INSTRUCTIONAL BULLETIN NO. 17-09

Regarding Revised Standard Drawings

Effective February 9th, 2018 letting (November 29th, 2017 Turn-in), the following Standard Drawings have been revised. Also, Section 5, Index of Standard Drawings, of the Roadway Design Guidelines has been revised to incorporate these changes.

TYPE 12
GUARDRAIL
TERMINAL
BURIED-IN-
BACKSLOPE

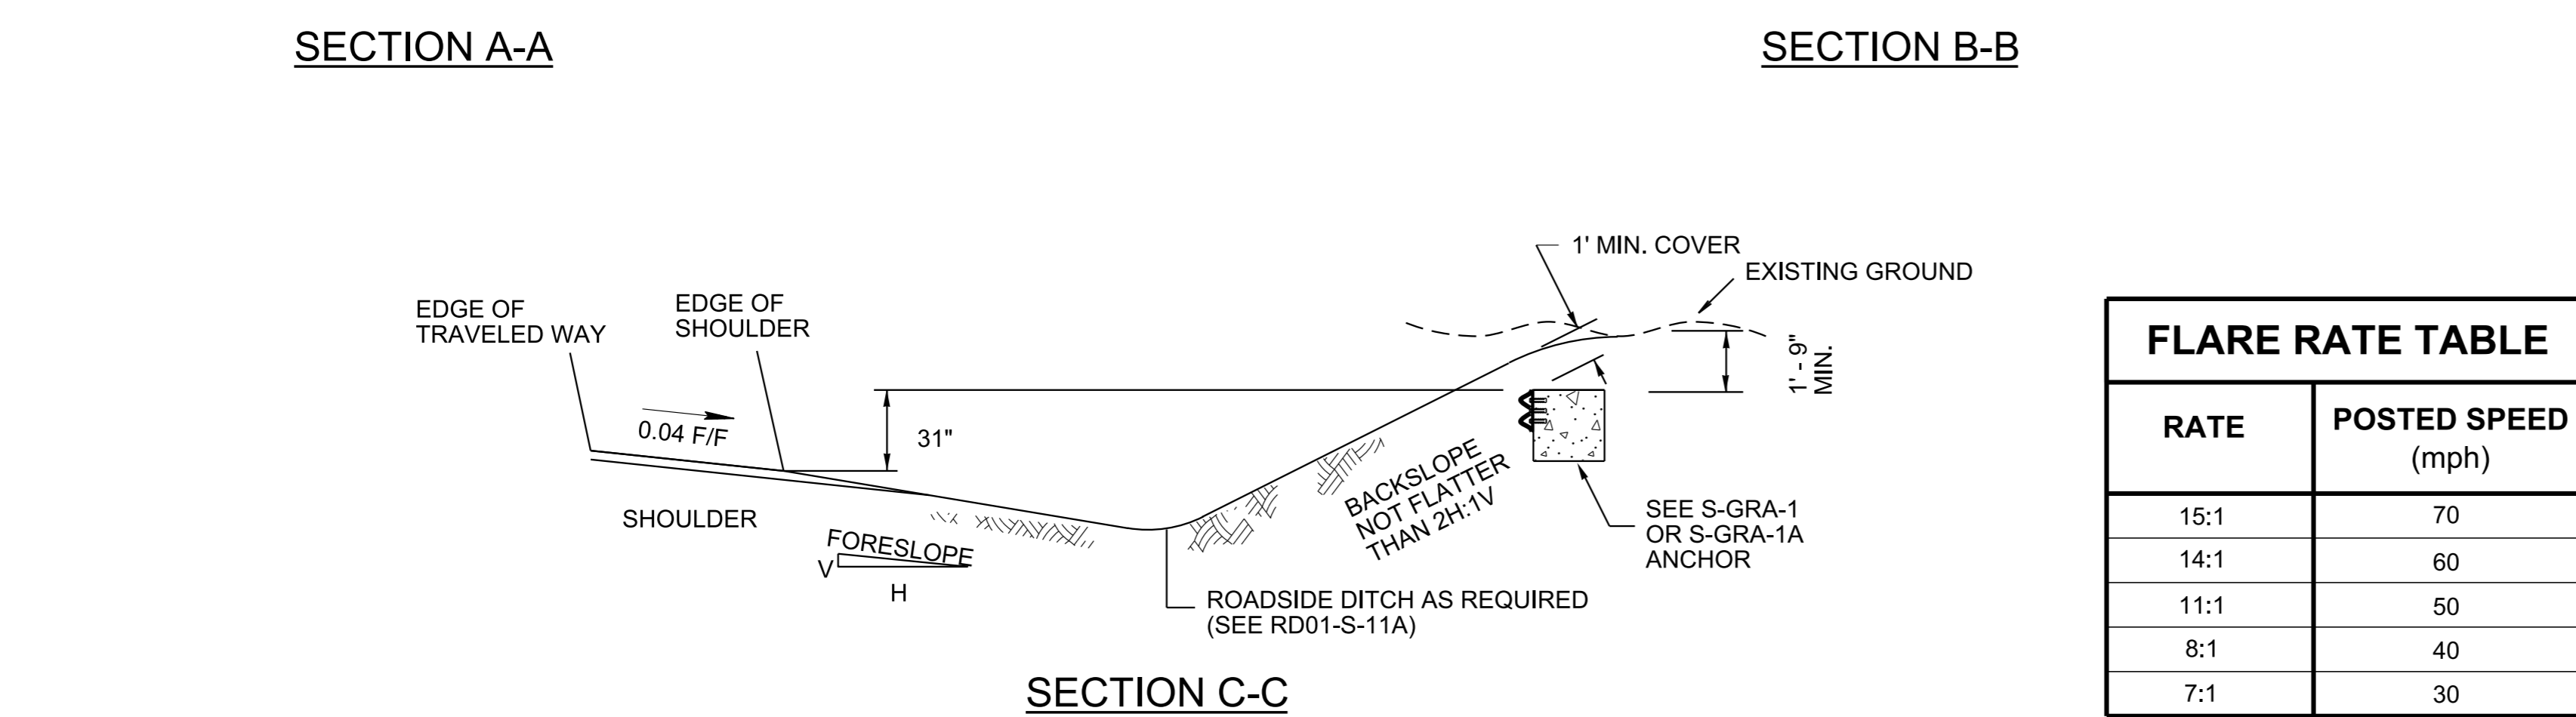
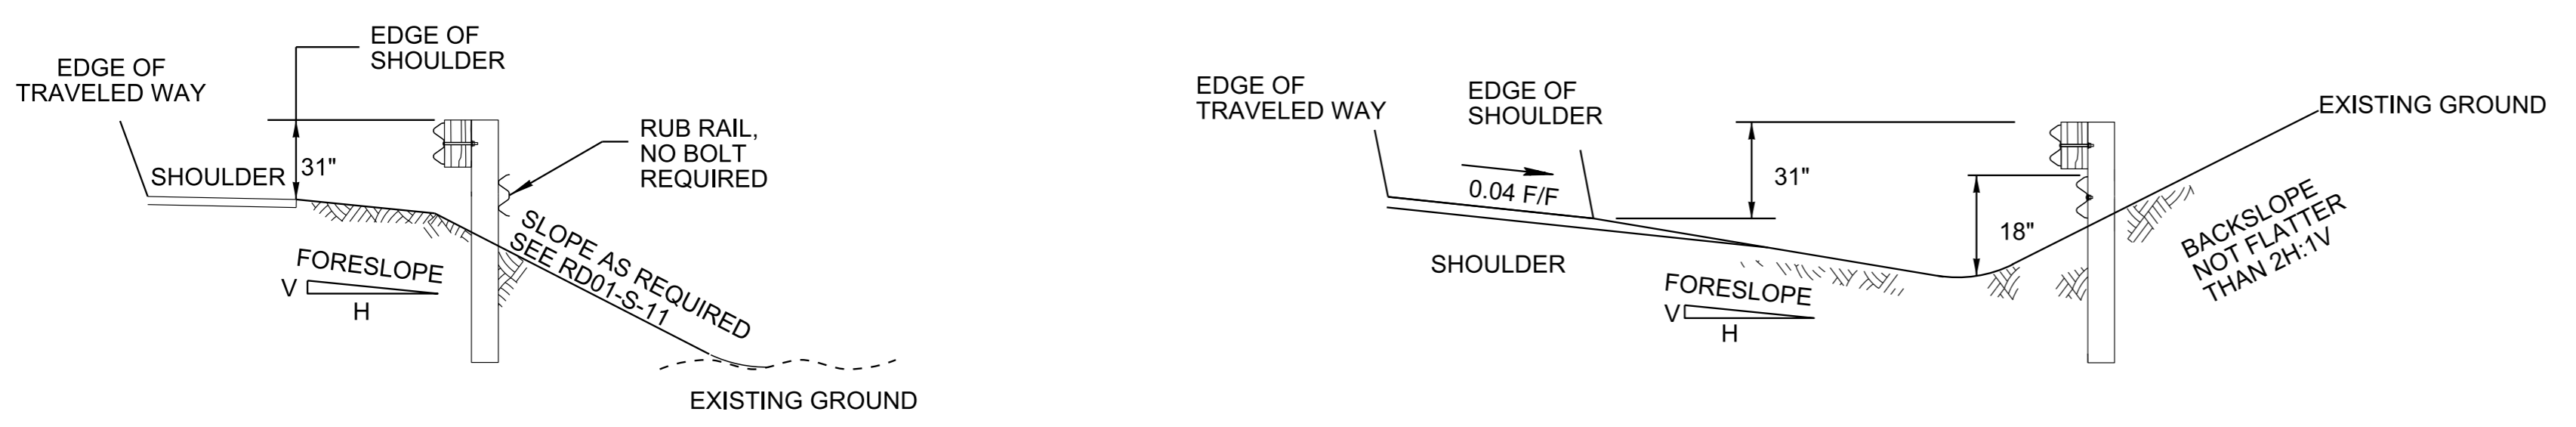
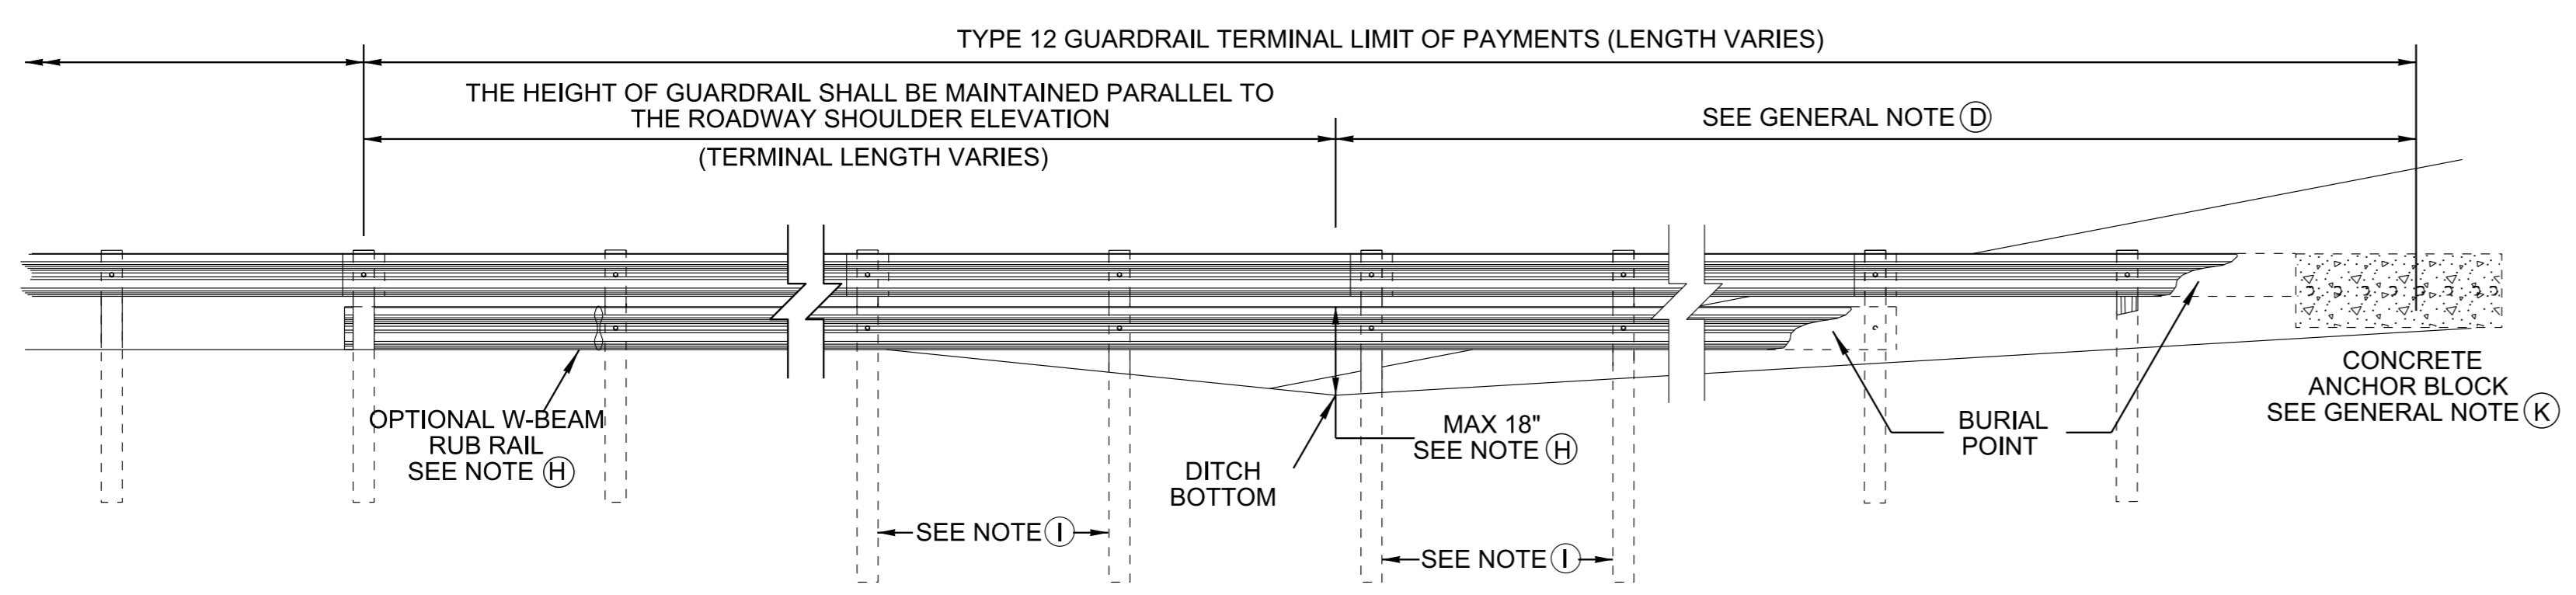
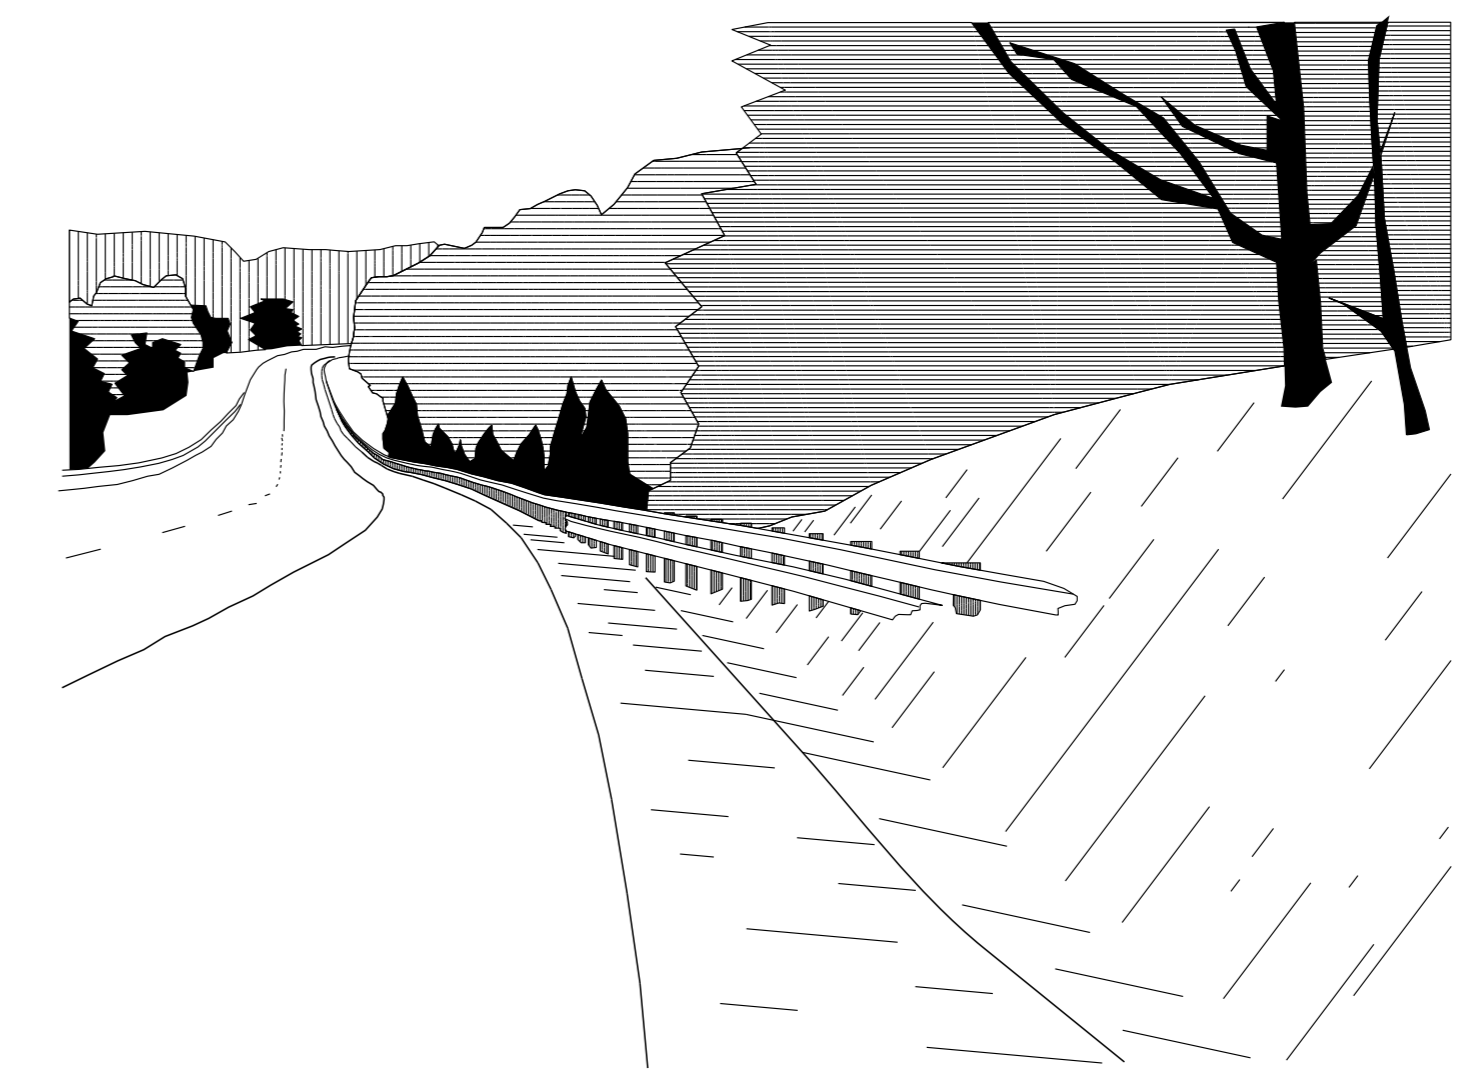
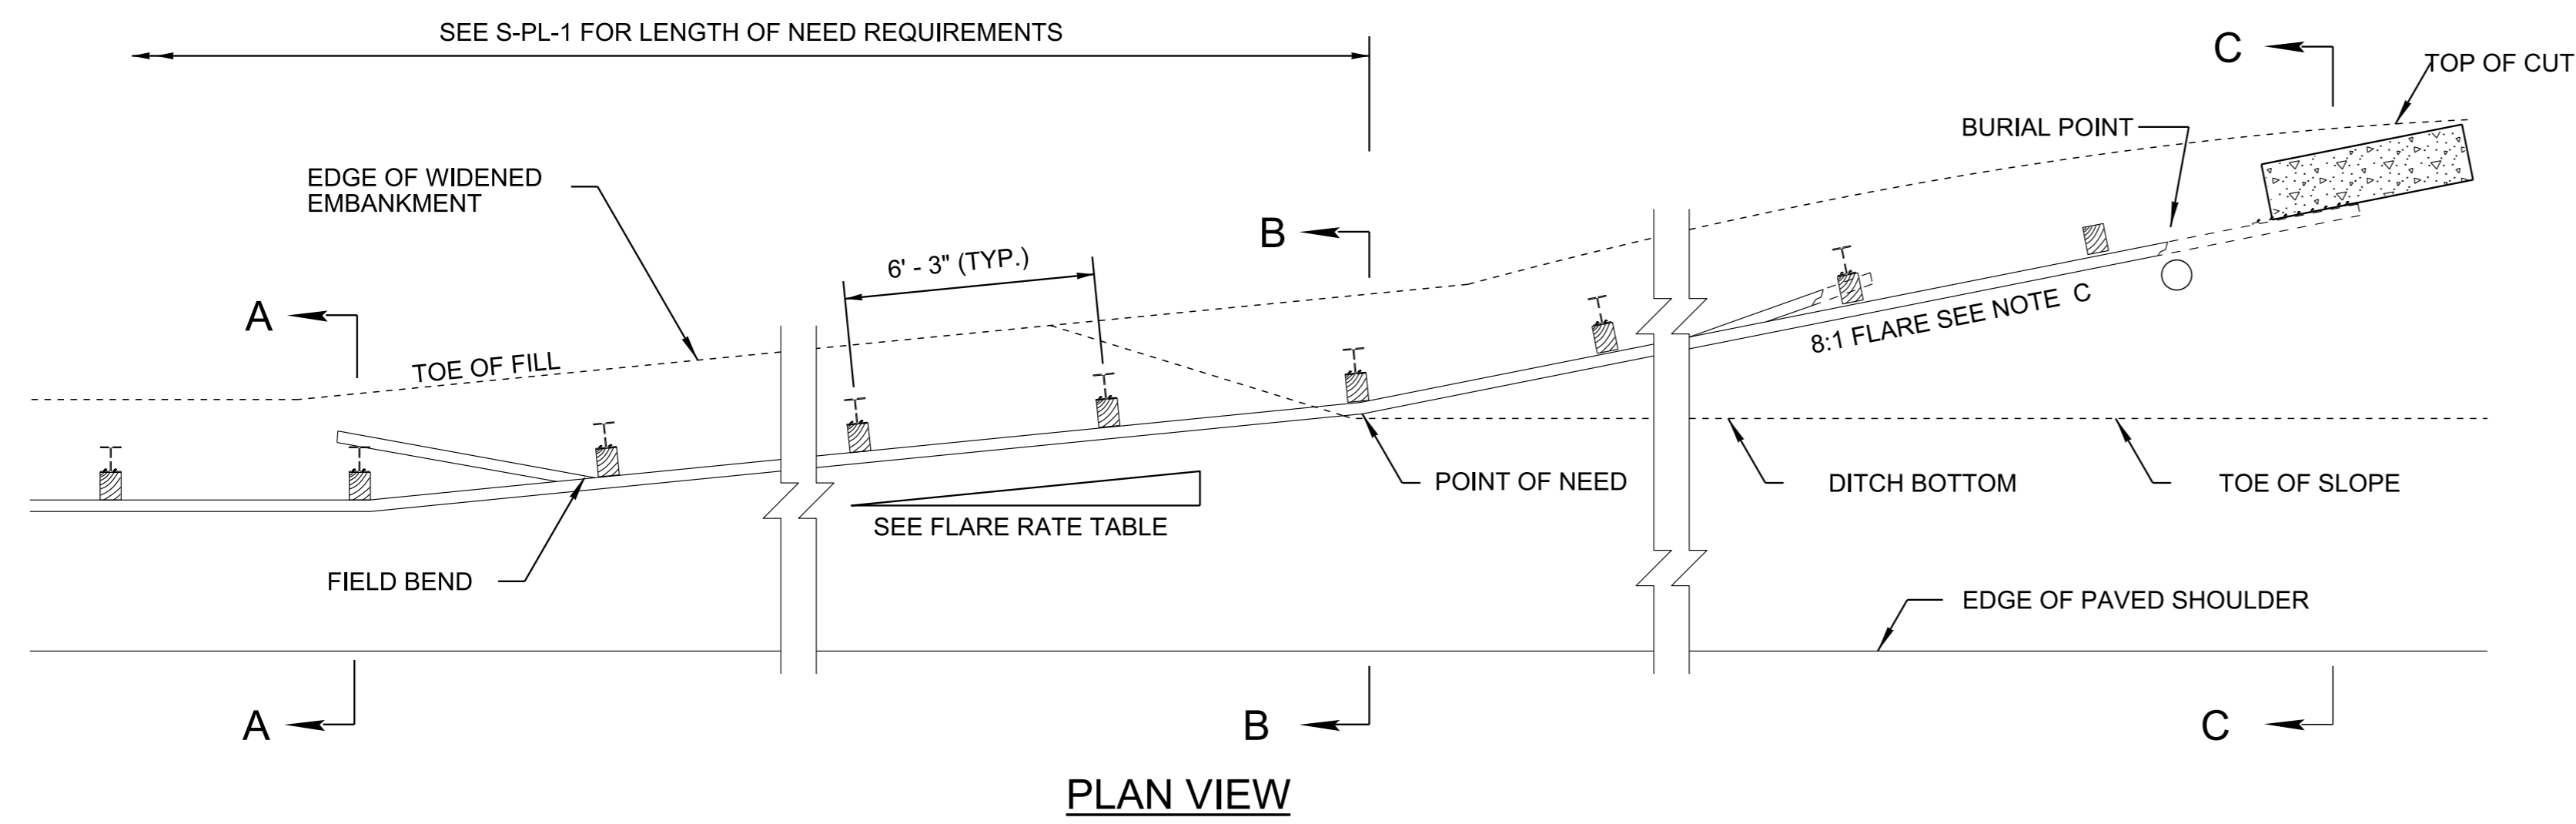
REV. 3-16-17: UPDATED REFERENCE TO STD. DWG. FROM "S-GRP-1" TO "S-PL-1". CORRECTED REF. TO STD. DWG. FROM "RD-S-11" TO "RD01-S-11" AND "RD-S-11A" TO "RD01-S-11A".
